# CITY OF CONWAY, ARKANSAS HISTORIC DISTRICT COMMISSION

April 24, 2023 • 5:30pm • 1111 Main Street

A. 812 Davis Street and 1724 Robinson Avenue - Modification to previously approved accessory structure and fence (HDR-0323-0056)

A. 2024 Johnston Avenue - New single-family residence (HDR-0323-0041)

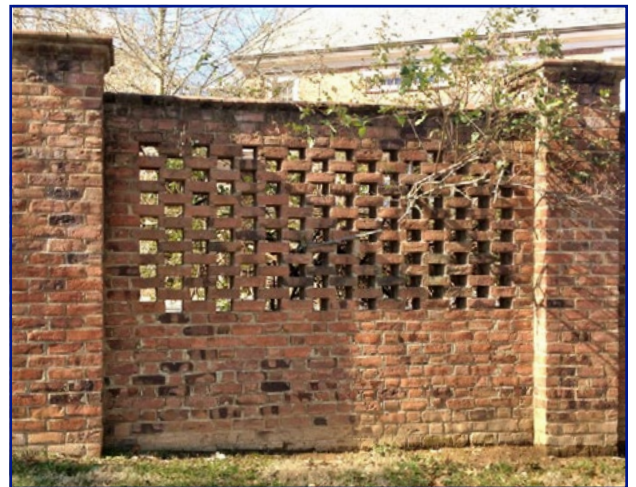
The applicant is requesting a modification to condition #1 to allow alternating brick courses in the top 2 feet of the 6' brick wall/fence, in lieu of ornamental metal, to provide the required 50% opacity as in the example photo.

While the proposal to use brick to provide the required opacity for the top 2' of the fence does not align with the RHD guidelines, the applicant discussed this option with the Commission at the December meeting and approval was implied. Also, the fence is to be installed as separation between a residential back yard and a institutional surface parking lot so the added security provided is appropriate given the context.

1. Allow a new fence in the rear and east side yard to be of ornamental metal, with or without brick piers, not to exceed 6' in height. Alternately, allow a solid brick wall, not to exceed 4' in height, in rear along east property line only. An additional 2' of ornamental metal *or alternating brick courses*, with at least 50% opacity may be added to the top for a total height not to exceed 6'.
2. Side yard fencing along Davis St to be of same style and height as adjoining 812 Davis St front yard fencing, not to exceed 48". Approved materials are ornamental metal with or without brick piers.
3. Allow a new fence in the front yard, along the east property boundary, to be constructed of ornamental metal only [without brick piers] and not to exceed 48" in height. Landscaping to be used to provide additional screening if desired.

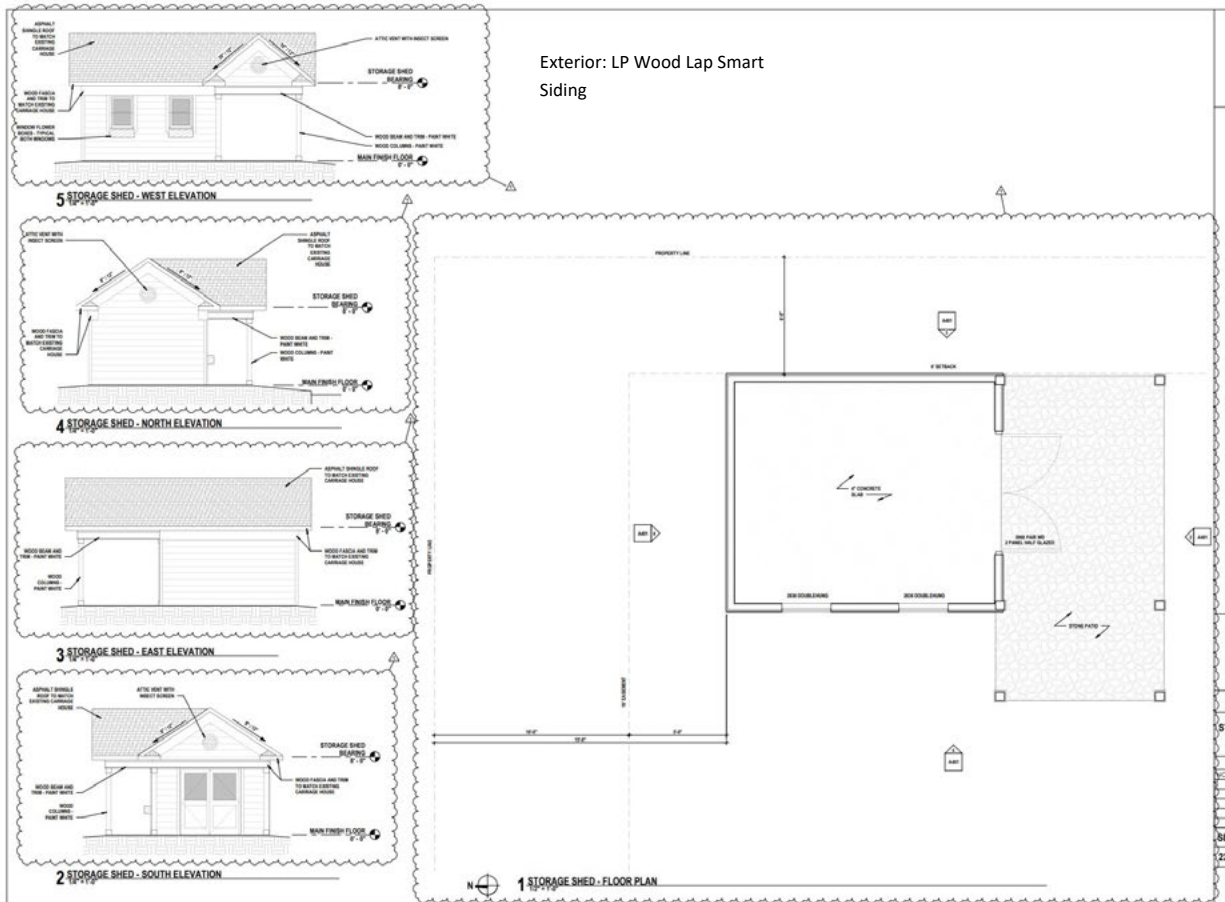
The applicant is requesting a modification to condition #1 to allow the material for the exterior façade to be exclusively LP® SmartSide® lap siding, instead of brick.

Both brick and wood or wood-like materials such as LP® SmartSide® or Hardie® siding are appropriate materials. No other previously approved design element (orientation, roof form, etc) is proposed to change.

Additionally, the portion of condition #3 pertaining to the rear yard fencing [only] is requested to be modified to align with that of 1724 Robinson Ave, if granted.

1. Primary material for the exterior façades of the accessory building should be composed of *either brick or wood or wood-like material such as LP® SmartSide® lap siding* ~~masonry that is similar in style and color to that found on the primary structure.~~

2. Wood or wood-like materials such as Hardie ® siding should be used for all fascias and soffits.
3. A new fence to the side yards and rear yard of ornamental metal, with or without brick piers, not to exceed 6' in height is permissible. Alternately, a solid brick wall, not to exceed 4' in height, in rear along east property line only is also allowable. An additional 2' of ornamental metal *or alternating brick courses*, with at least 50% opacity may be added to the top for a total height not to exceed 6'.

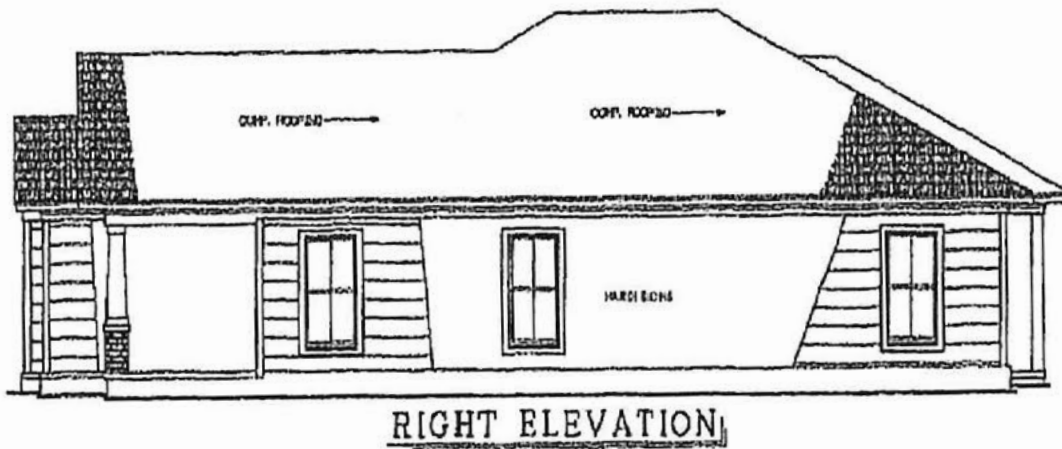
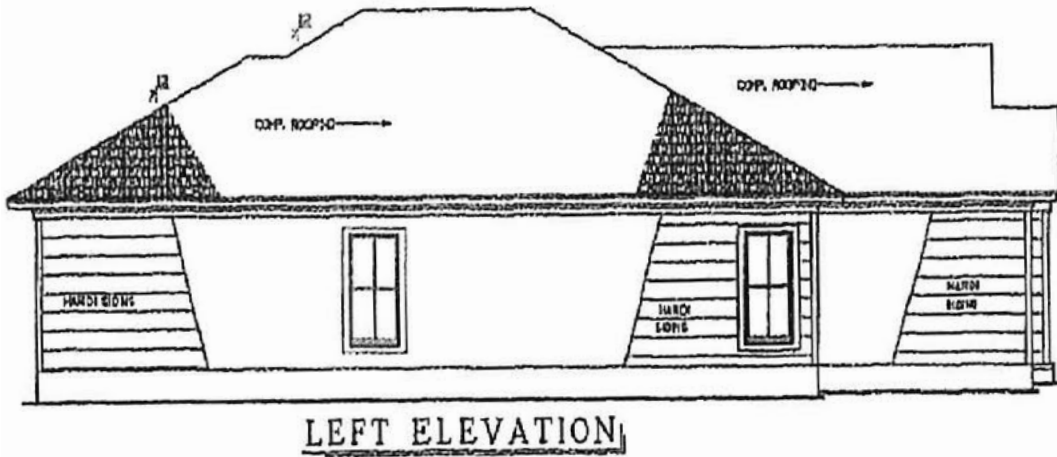
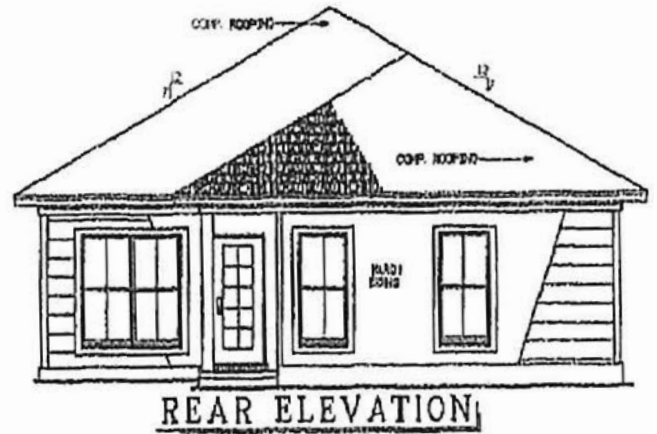
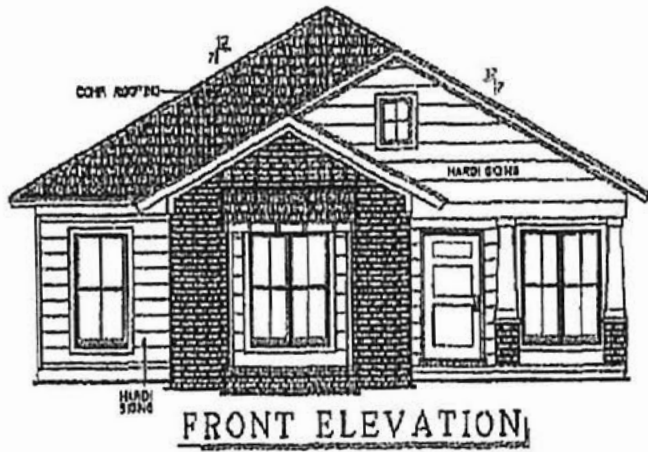
*The applicant is proposing brick and Hardie® siding as the materials for construction.*

*No shutters are being proposed which is desirable. The applicant is proposing a gable roof in the front with a hip roof on the sides and rear. This is compatible with surrounding homes.*

1. Windows shall be one-over-one. If muntin bars are used, they must be true divided lights.
2. Overall height of the structure must be compatible to those found in the area; provide proposed height to staff.
3. 25-40% of front elevation must contain windows.
4. Driveway length, width, and material must be provided prior to issuance of a certificate of appropriateness. Driveway shall be concrete, pavers, or permeable paving.
5. A 5' sidewalk with 6.5' greenspace is required. Sidewalk must link to any existing sidewalk.
6. Care should be taken to preserve all significant trees on the property. Any canopy tree removed must be replaced by a canopy tree from the approved tree list.

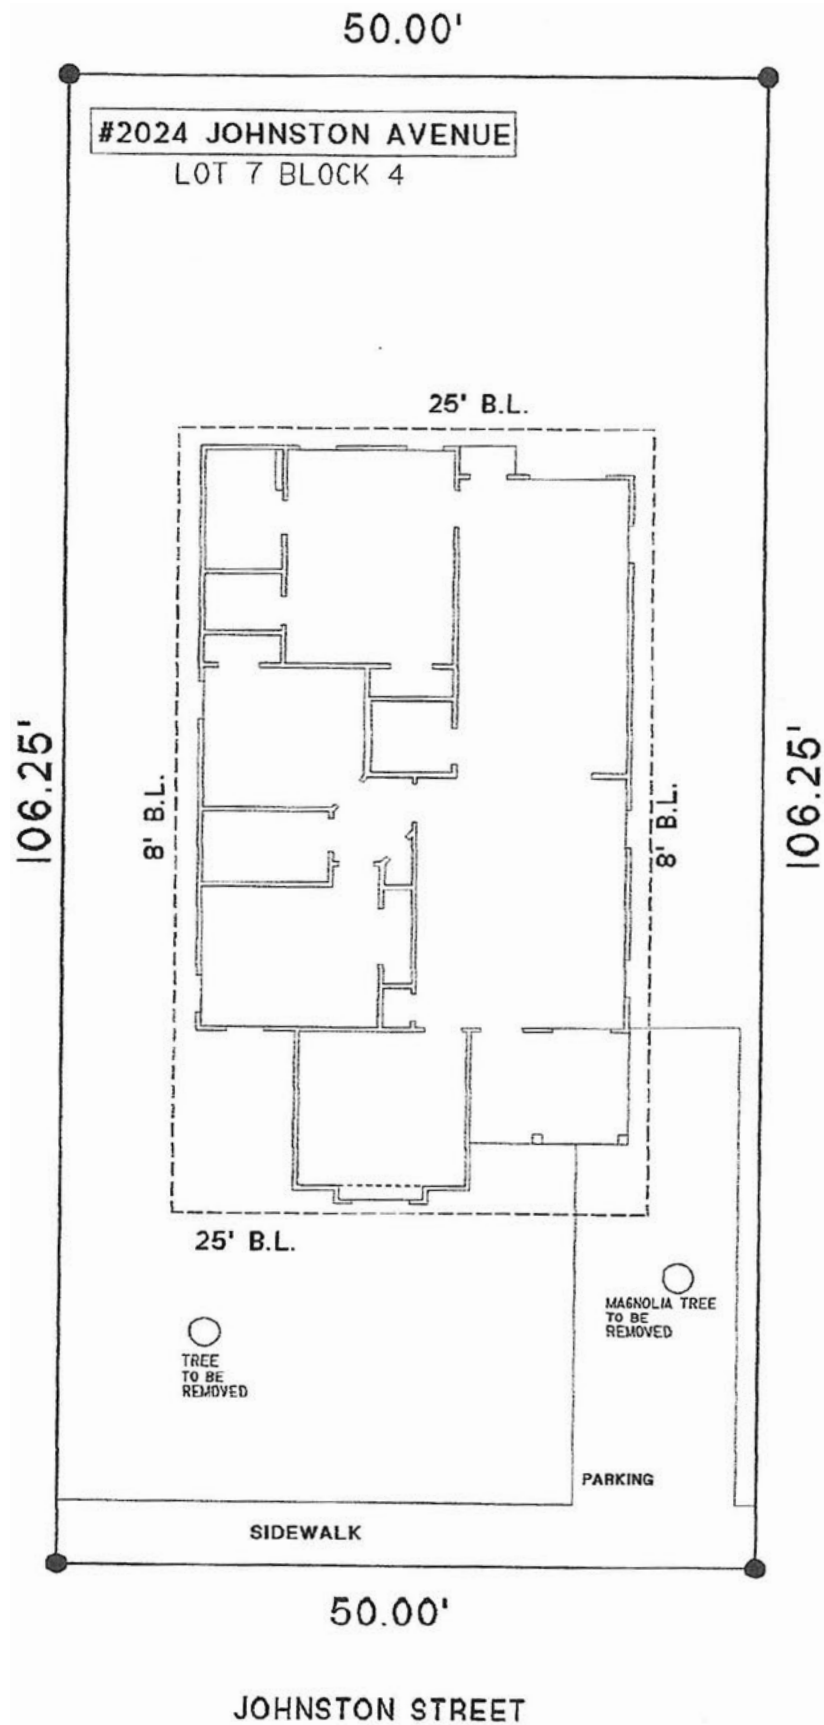
*The applicant has indicated a driveway off of Johnston Ave near the east property line. The width and length of the parking area has not been provided, nor has the material used for the parking surface. The plans cannot be adequately evaluated due to a lack of information on the plans for driveways.*

*There are no existing sidewalks on the site. However, the applicant does show a sidewalk to be placed along Johnston Ave. This sidewalk shall link to the existing sidewalk to the east. A 5' sidewalk with a 6.5' greenspace setback is required along the frontage.*

*It appears numerous significant trees will be impacted by the construction. The site plan indicates two significant trees will be removed from the front yard of the proposed dwelling. There is a significant tree in the rear, but this is not addressed on the site plan. Each canopy tree removed is required to be replaced by a canopy tree from the approved tree list. Plans should indicate all trees to be removed and preserved and the planting of any new canopy trees.*
